File Ref: S523190_RFIR2_v1.0

42 REDHEAD STREET, DOOLANDELLA (A006866747) – RESPONSE TO INFORMATION REQUEST – FURTHER ISSUES

I refer to the above Brisbane City Council (BCC) issued Information Request letter to address further issues regarding the Change application for the proposed Development Permit for Material Change of Use – Multiple Dwellings (27 Townhouses) at 42 Redhead Street, Doolandella (herein referred to as the 'subject site'), dated 1st of June 2026. Specifically, this response letter aims to address Items 1-6 of the Information Request.

DRAWING NO.
S523190_VRP_001

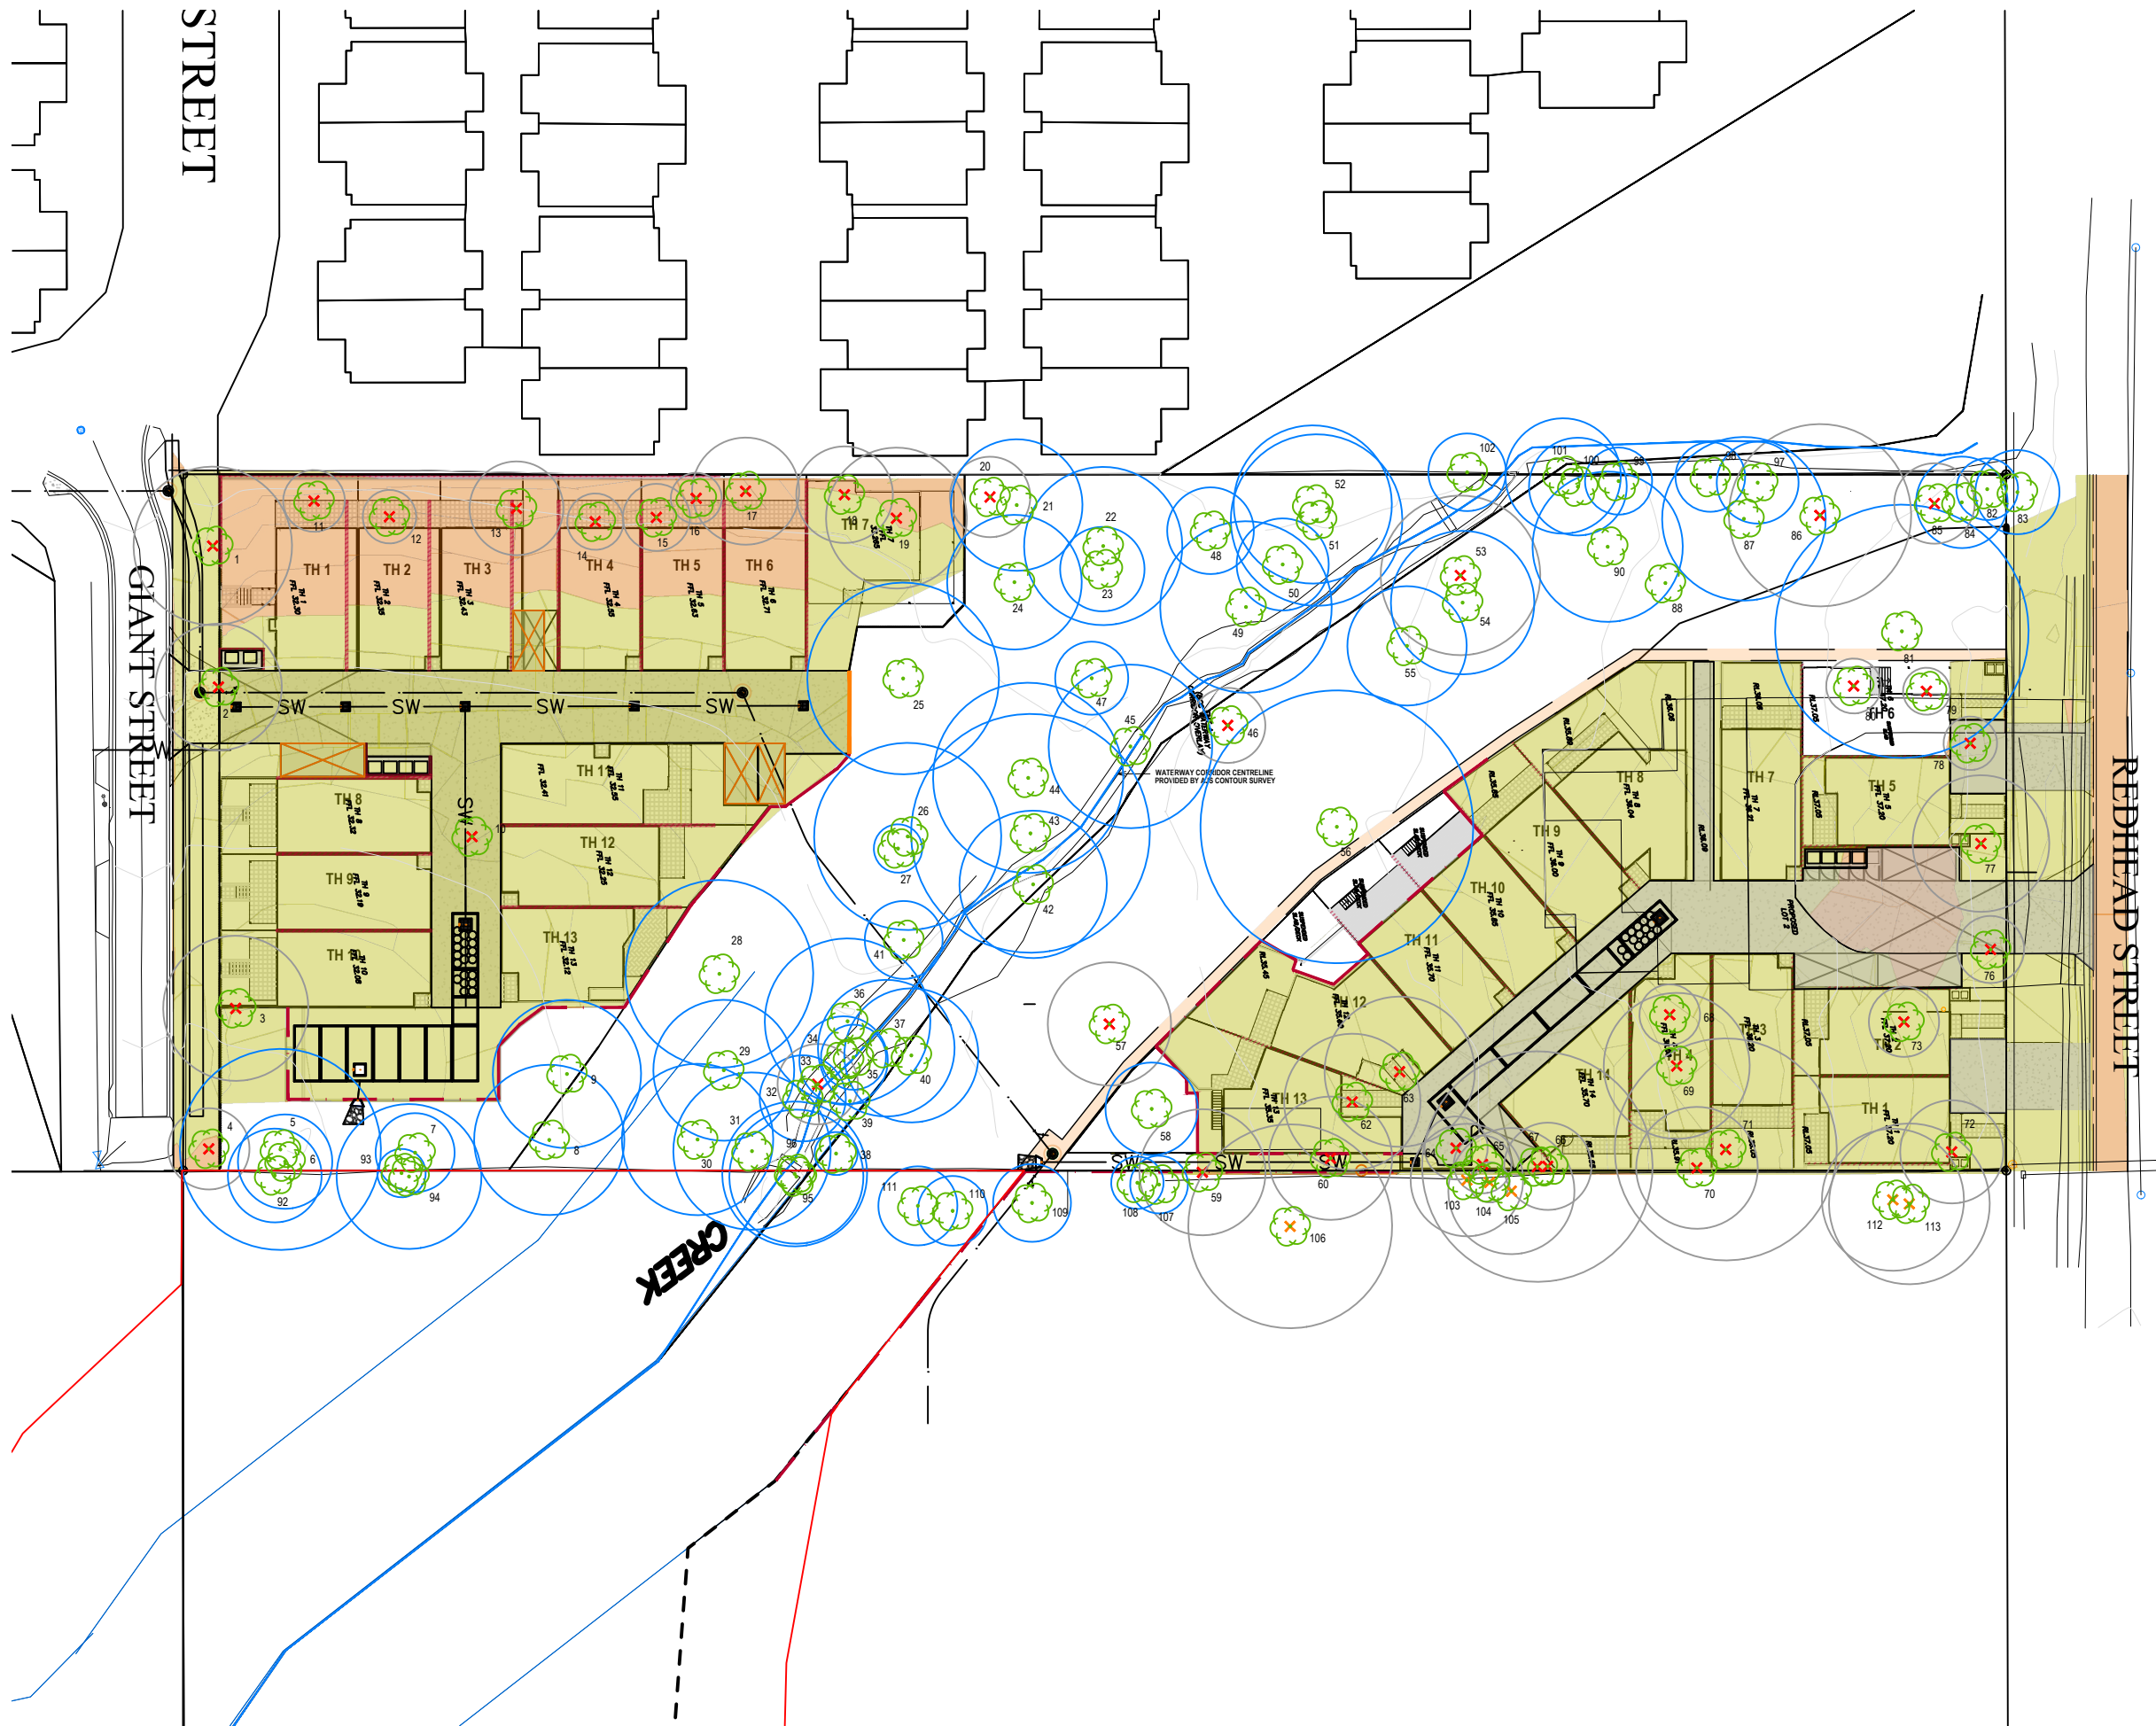
v. Resolve the discrepancies regarding tree retention between the Arborist Report and the VRP (e.g. T59 and T60 are identified for retention in the Arborist Report but shown for removal in submitted plans).

vi. Identify only vegetation proposed for retention or removal. Previously removed vegetation as identified in the Arborist Report is to be removed from plans.

Please refer to the updated Vegetation Retention Plan within **Appendix B**, demonstrating the retention of T81, 56, 21, 22, 24, 25 and 9 within the Waterway Corridor. Acceptable levels of encroachment within the NRZ have been demonstrated and supported by the project arborist (please refer to the associated Arborist Report prepared by Independent Arboricultural Services).

Trees 59 and 60 are to be removed and all plans have been updated to reflect this. Please refer to the associated Arborist Report prepared by Independent Arboricultural Services.

DRAWING NO.
S523190_VRP_004

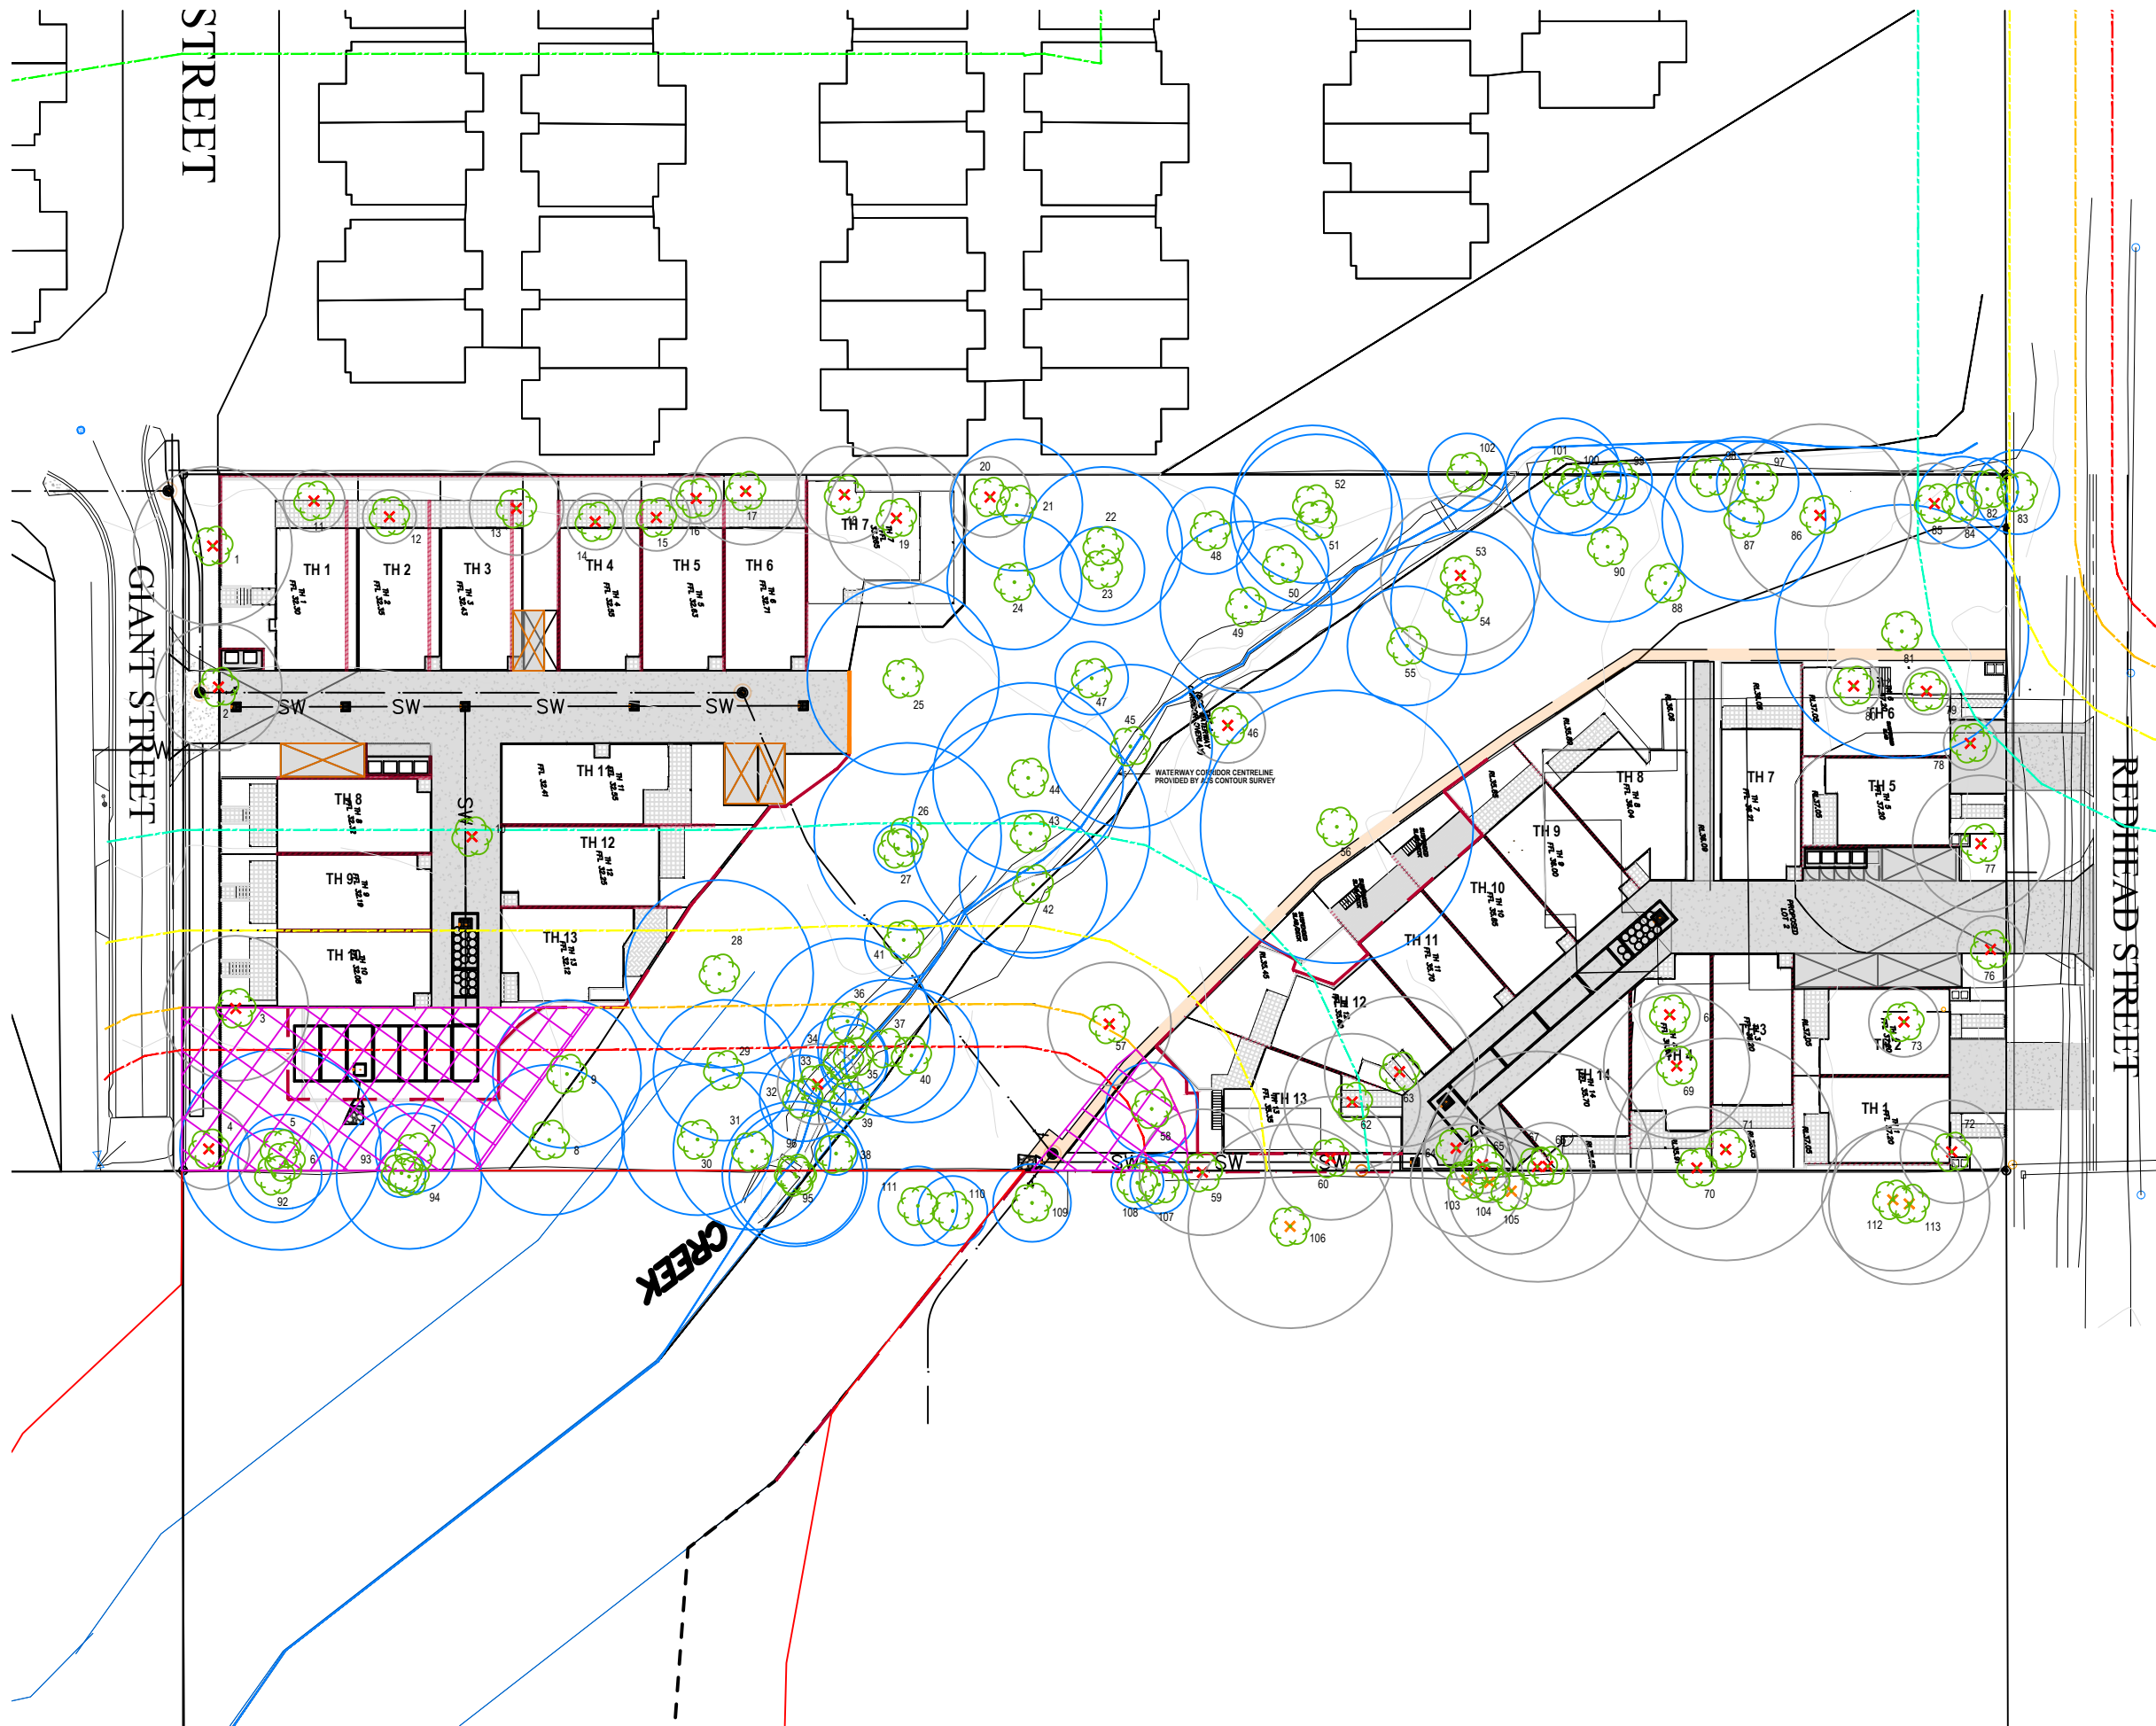
2) The submitted Vegetation Retention Plan BAL Setbacks (Drawing No. S523190_VRP_004, BCC received 05/05/2026) identifies proposed development, including Townhouses 12 and 13, within the bushfire management zones (i.e. areas exceeding a radiant heat flux of 29 kW/m²). This does not comply with PO1 of the Bushfire overlay code and is not supported.

c. Updated development plans incorporating required layout changes based on the bushfire assessment and overlay code provisions (i.e. development sited to achieve radiant heat flux of 29kW/m² or less). Plans must clearly identify bushfire management zones and setbacks within the staged development. Bushfire management zones are to be contained within the development footprint; impacts to, removal of or reduction in the ecological values will not be supported.

Please refer to **Appendix B** for the updated Vegetation Retention Plan (S523190_VRP_001-006(F)) of which includes the updated development plans incorporating required changes based on the BHAMP, with the development sited to achieve a maximum radiant heat exposure of 29kW/m². The bushfire setbacks outlined within the attached BHAMP are shown on VRP004.
